# Addendum

**Project:** Harris County Psychiatric Center Renovation  
Units 1C, 2E, 3B, 3C, 3D, & 3E

**Addendum No.:** 002

**Date:** November 14, 2016

# A8.01

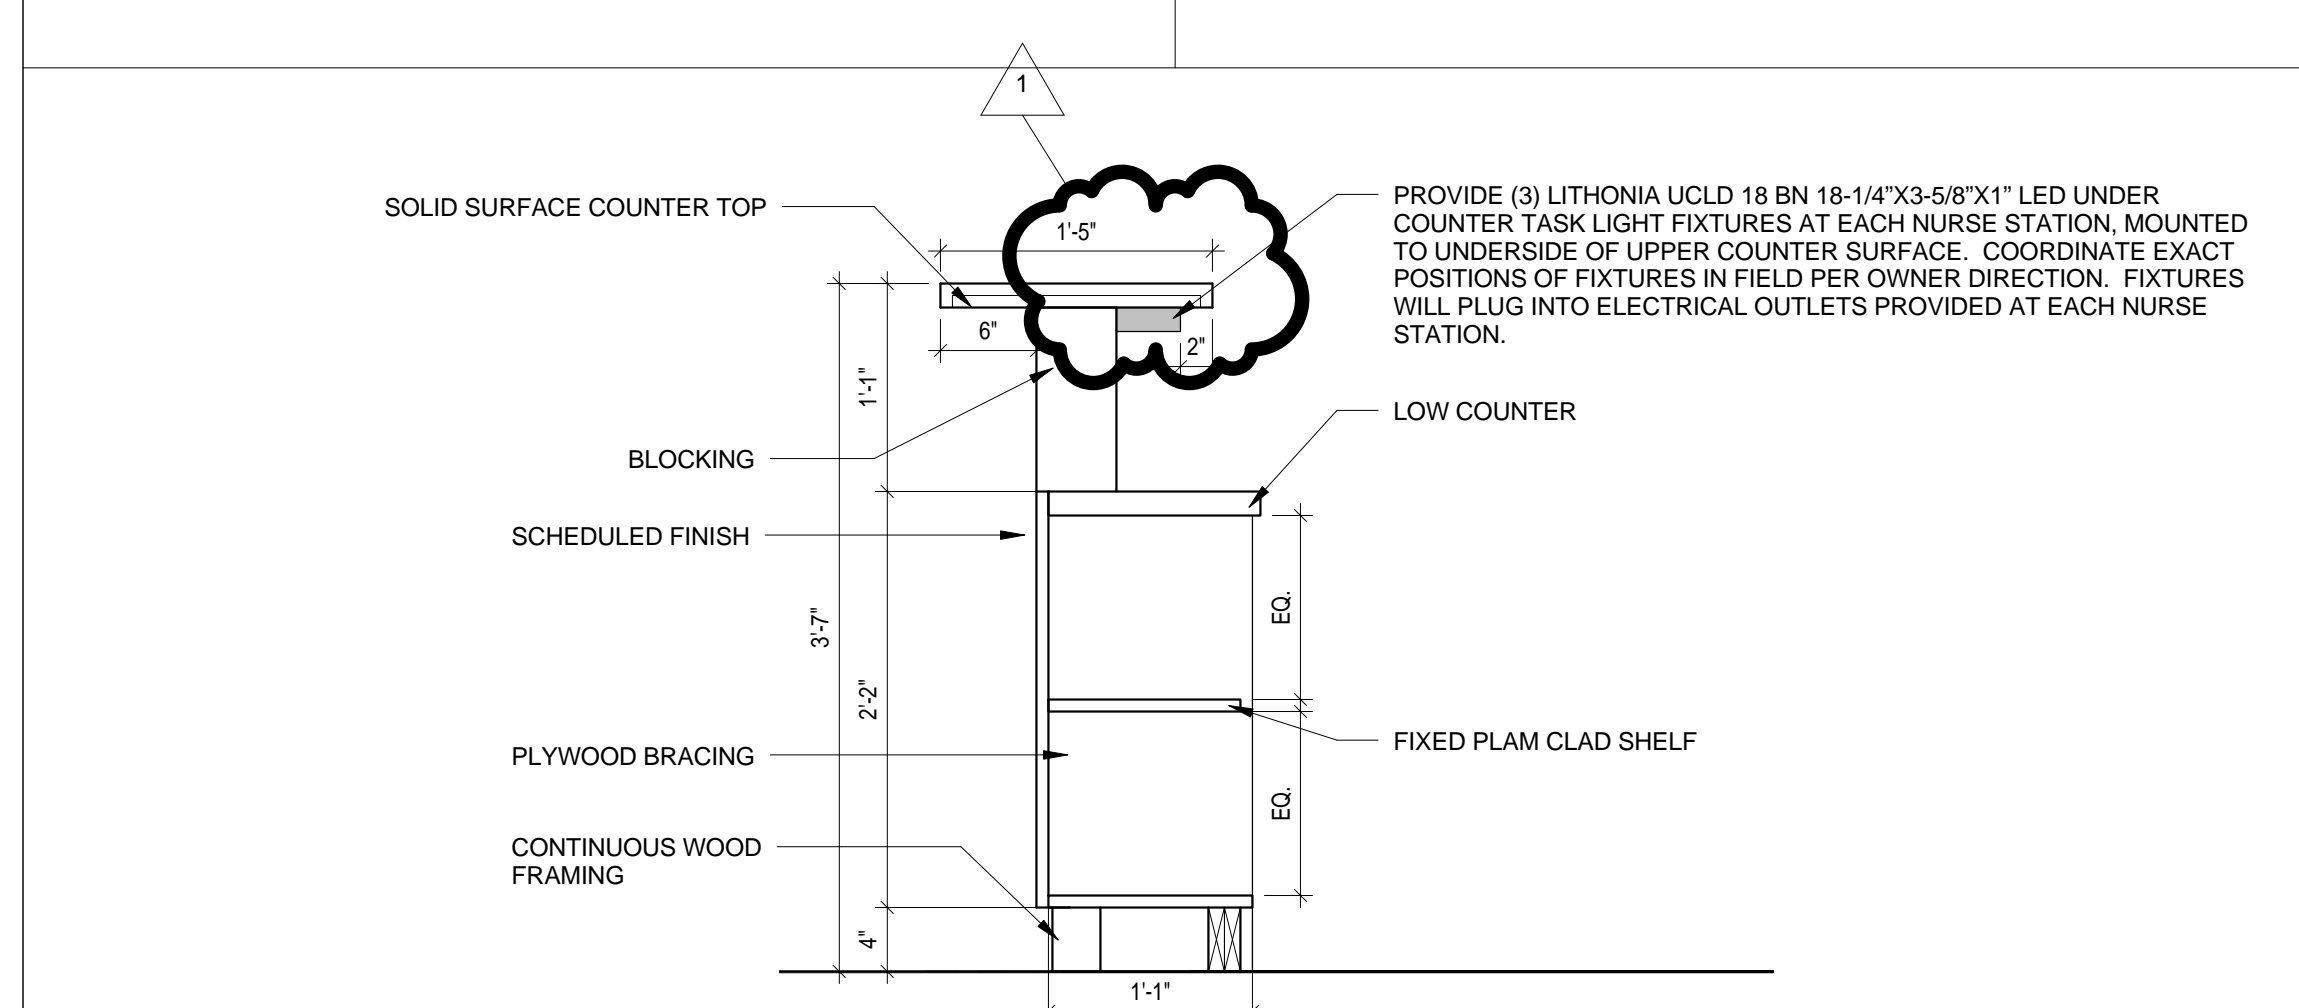
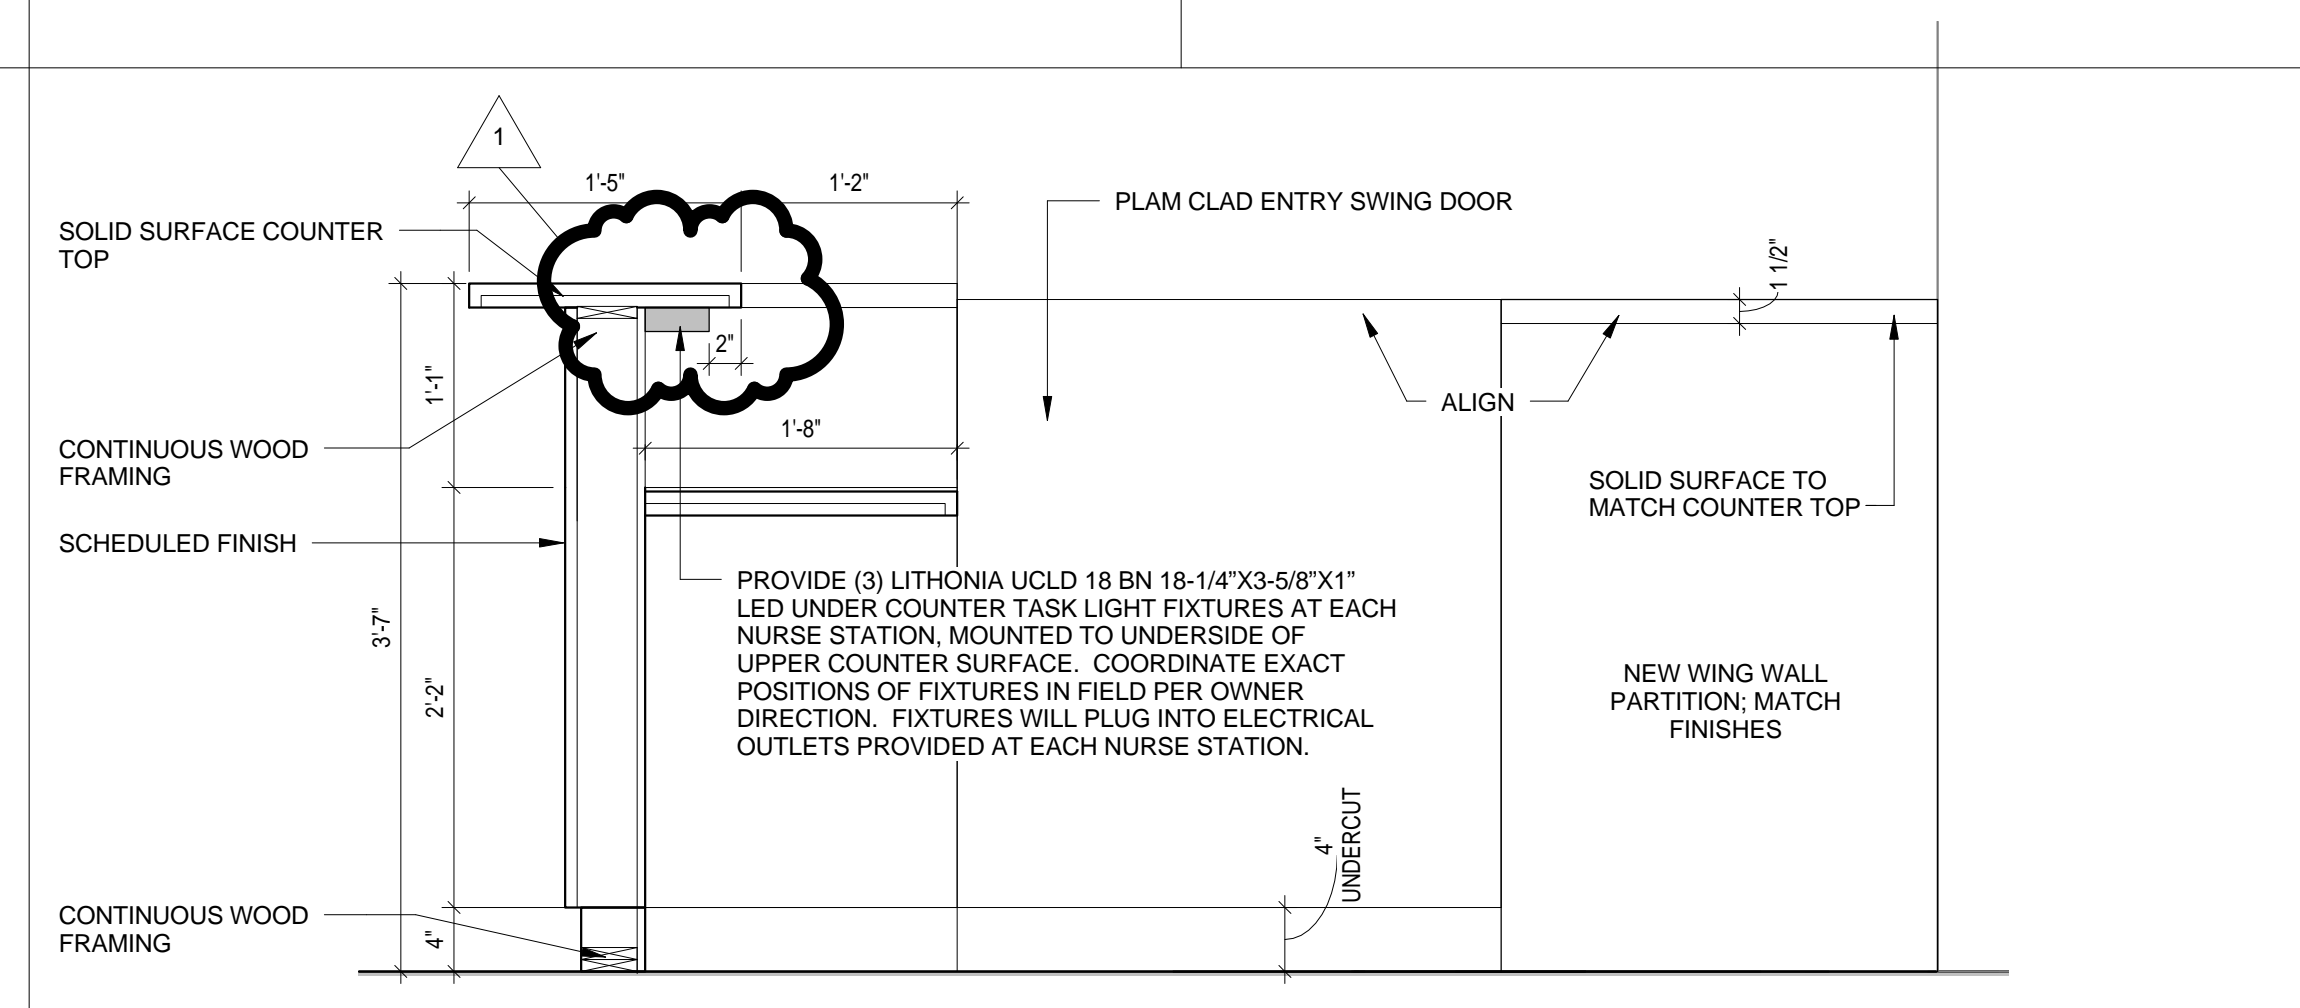
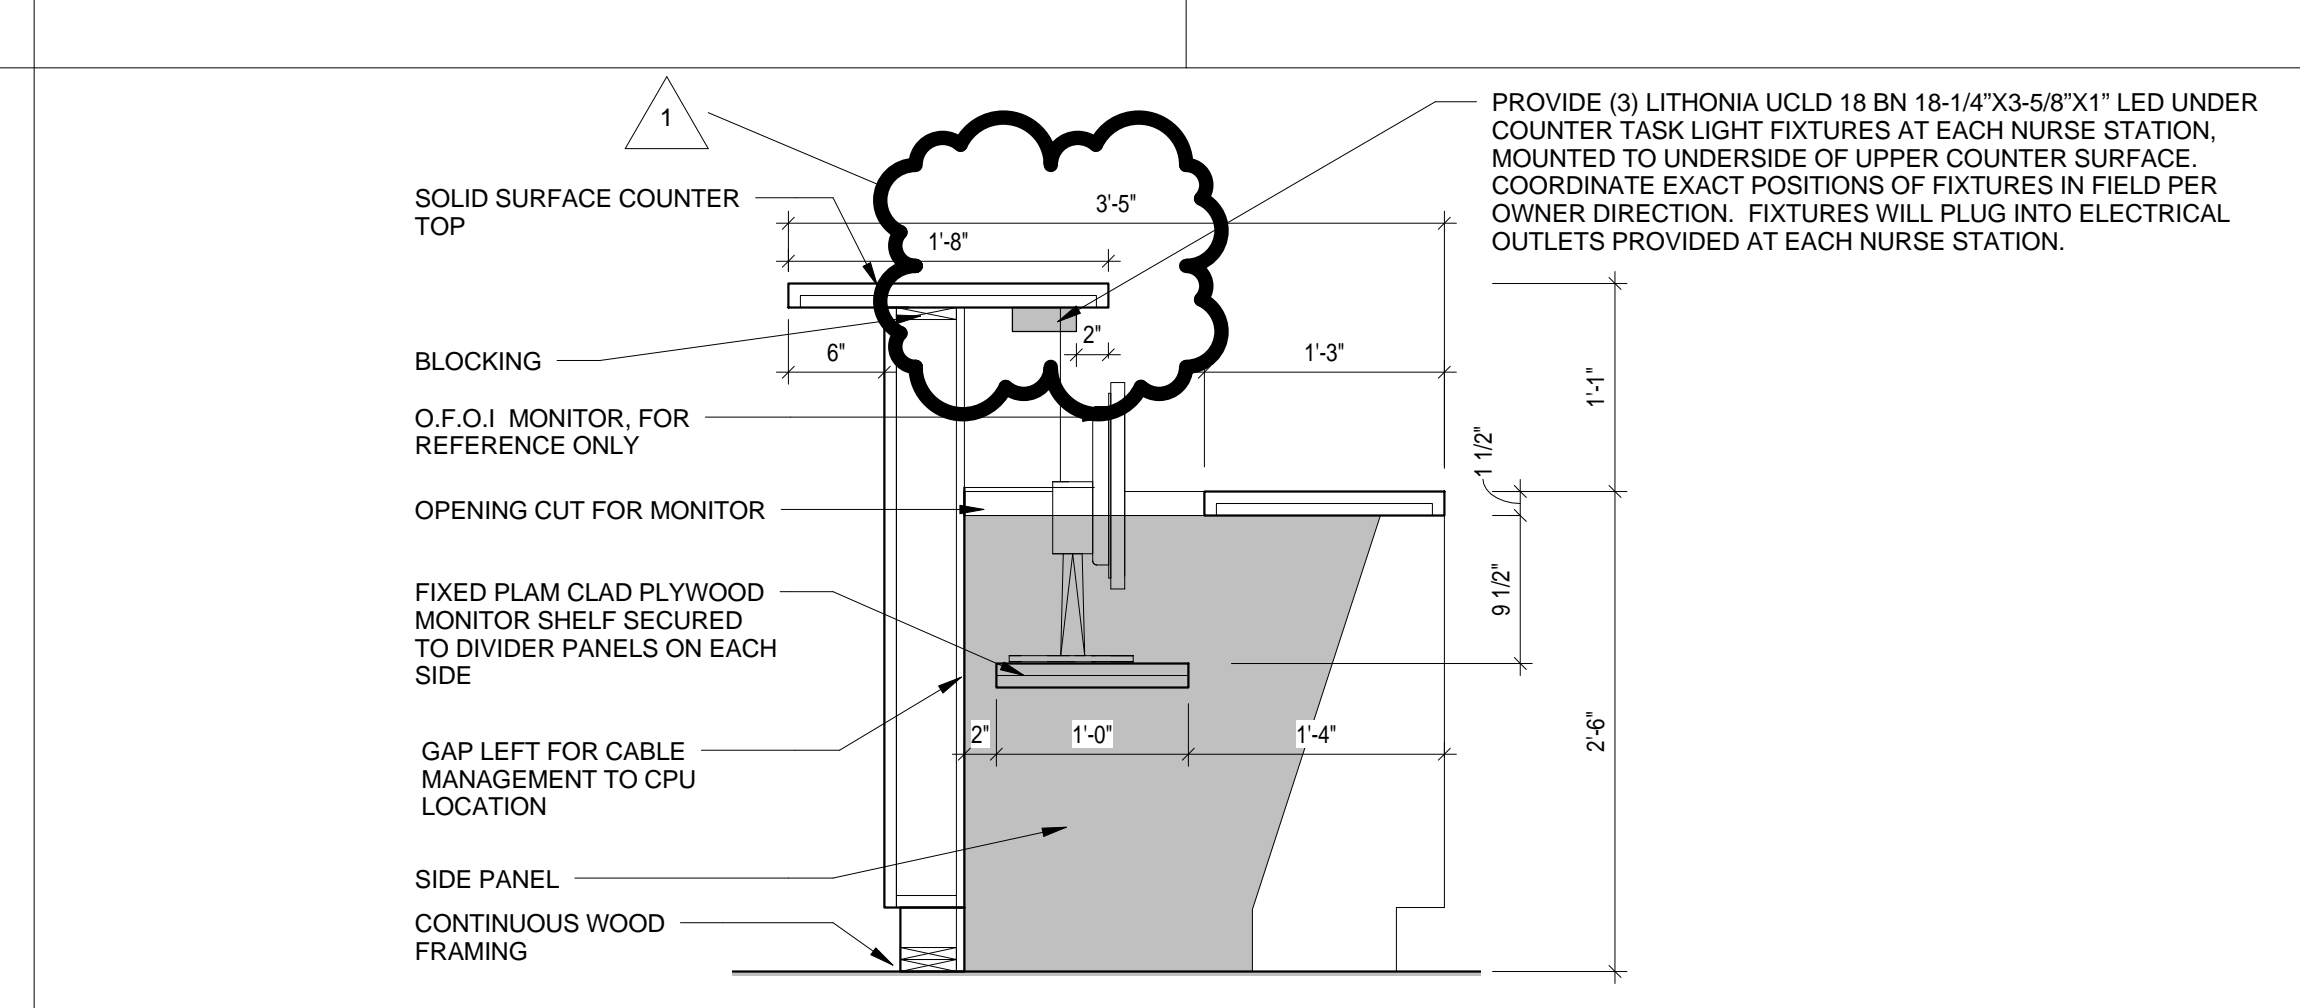
13. Sheet A8.01, Millwork Sections, revised to reflect the addition of under-counter task lighting at each Nurse Station millwork section detail. (see attached)

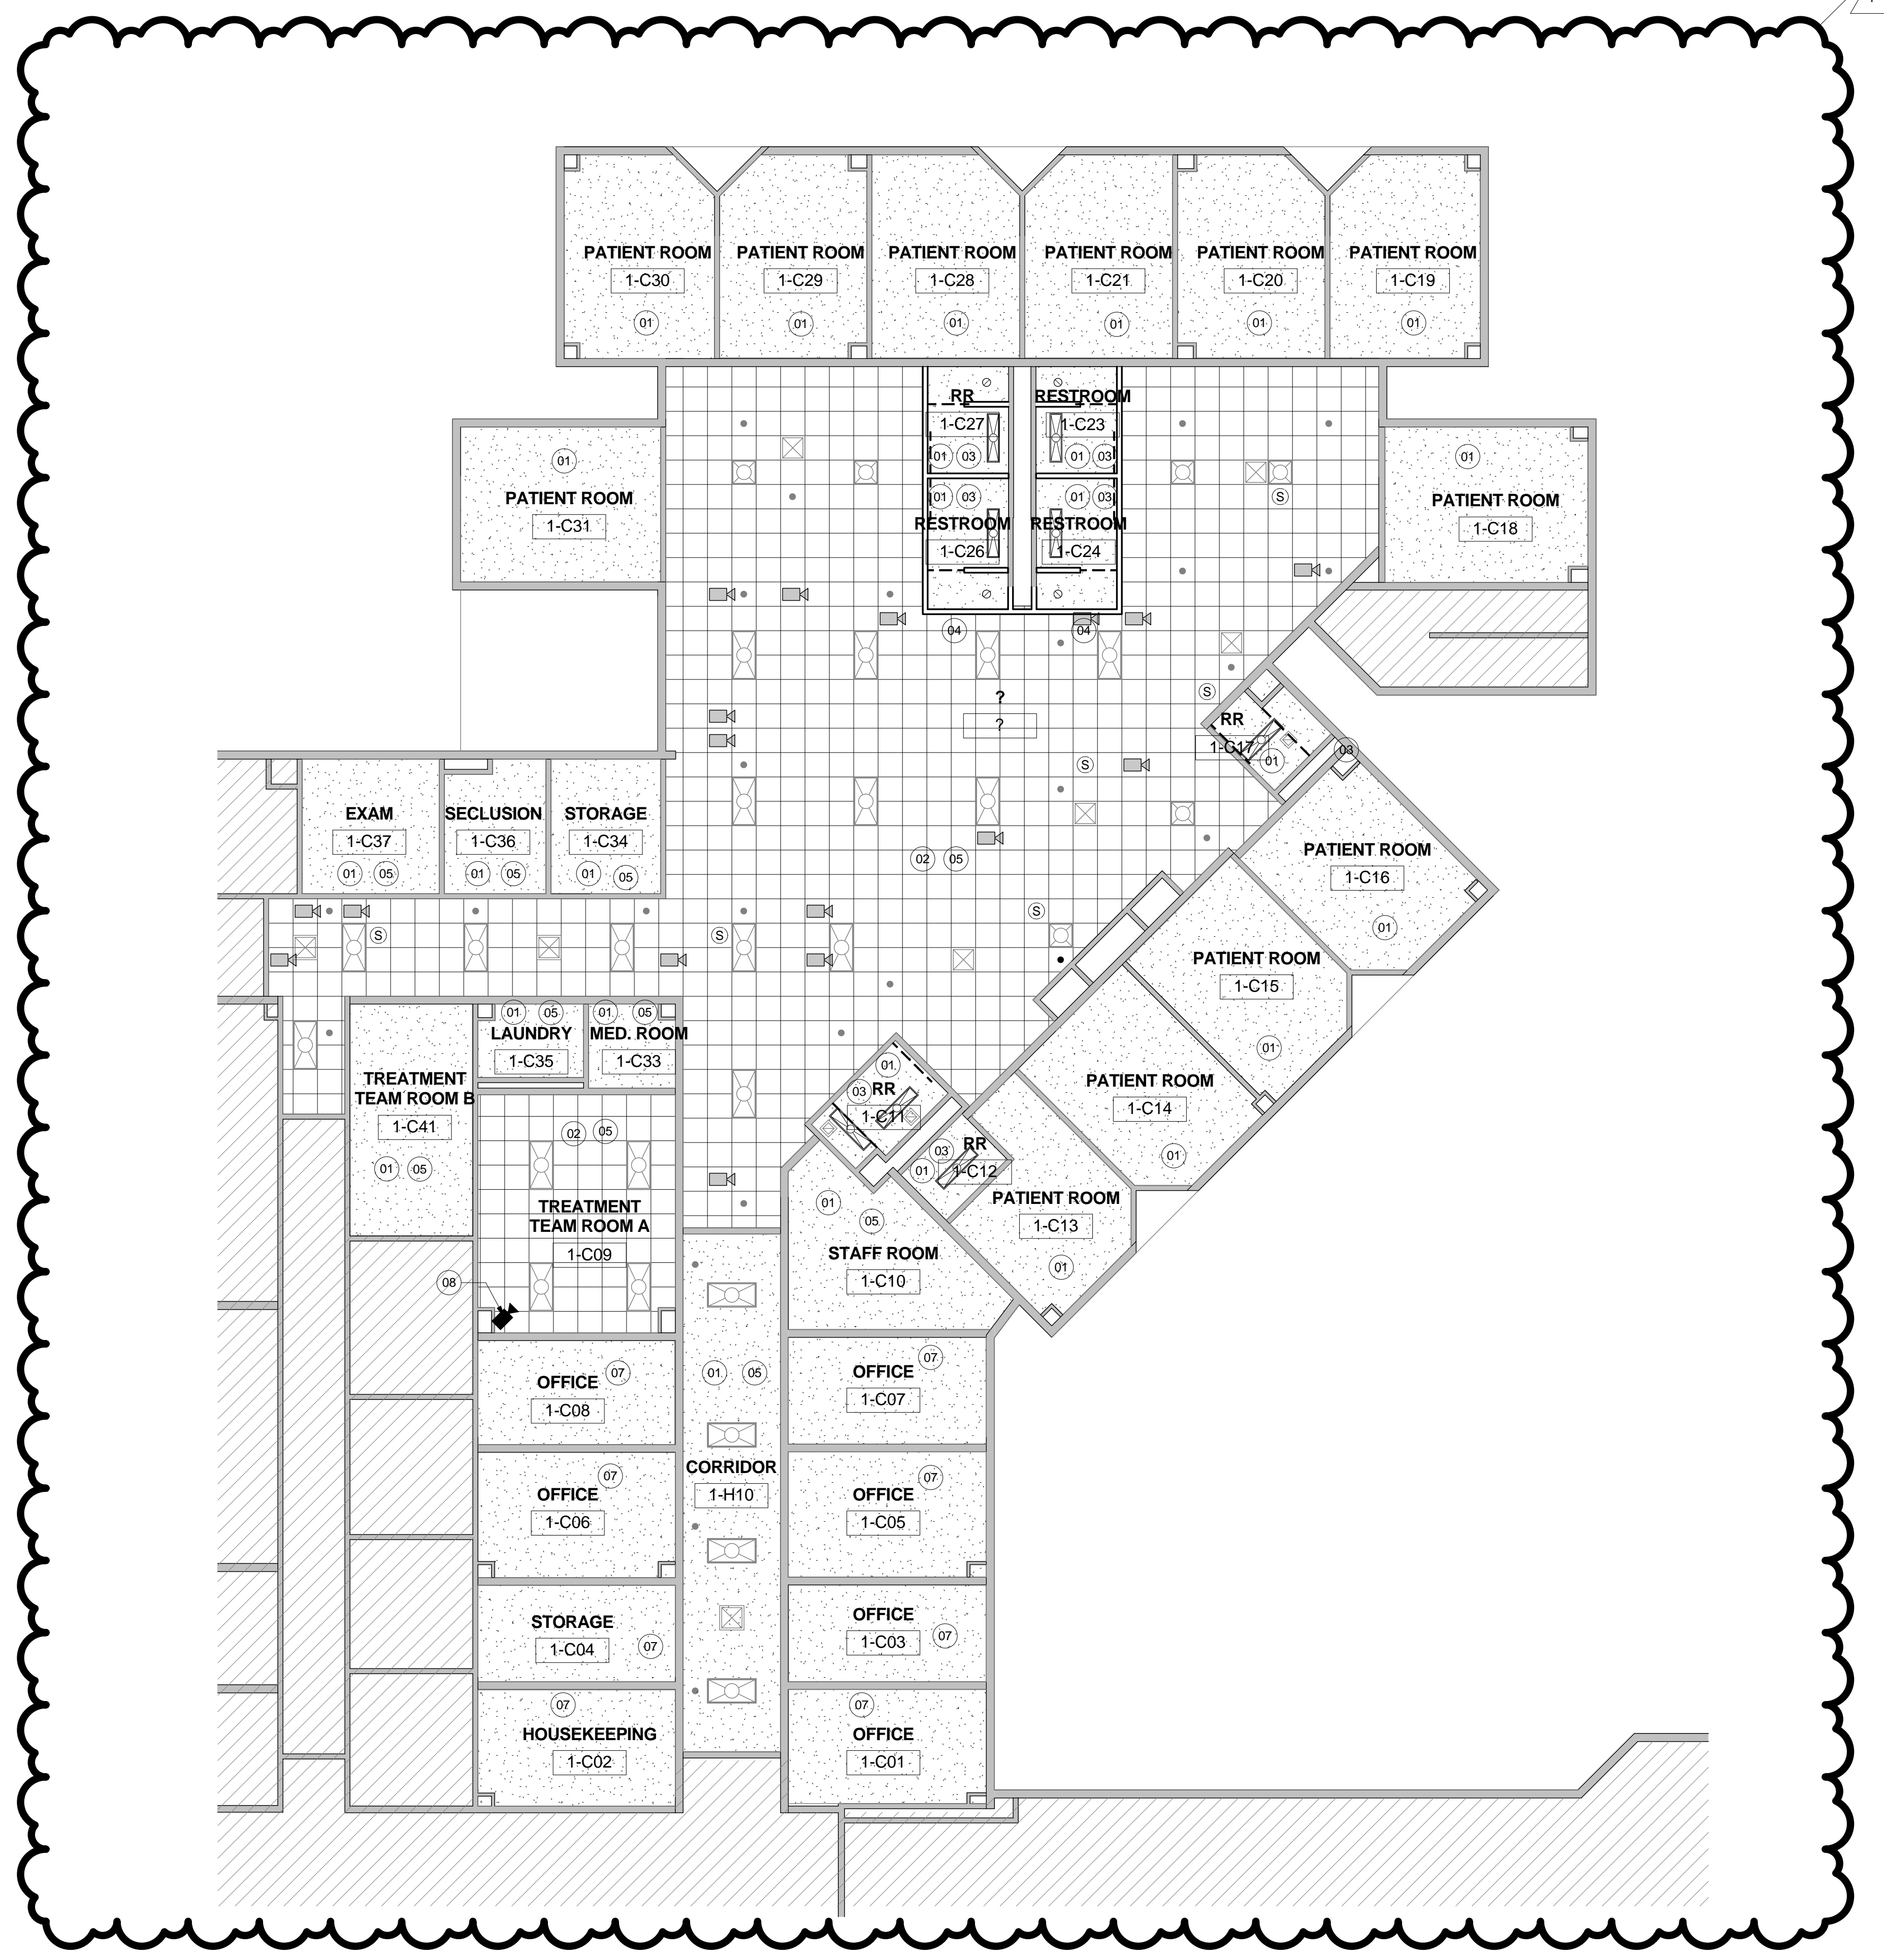
14. Sheet G0.04, Fire Alarm Devices, added to Drawings for reference only.
15. Sheet A10.01, Reflected Ceiling Plan – Unit 1C First Floor, revised to reflect changes to keyed note text and placement on the reflected ceiling plan in order to provide additional clarification regarding the scope of work pertaining to existing and new light fixtures throughout the unit. (see attached)
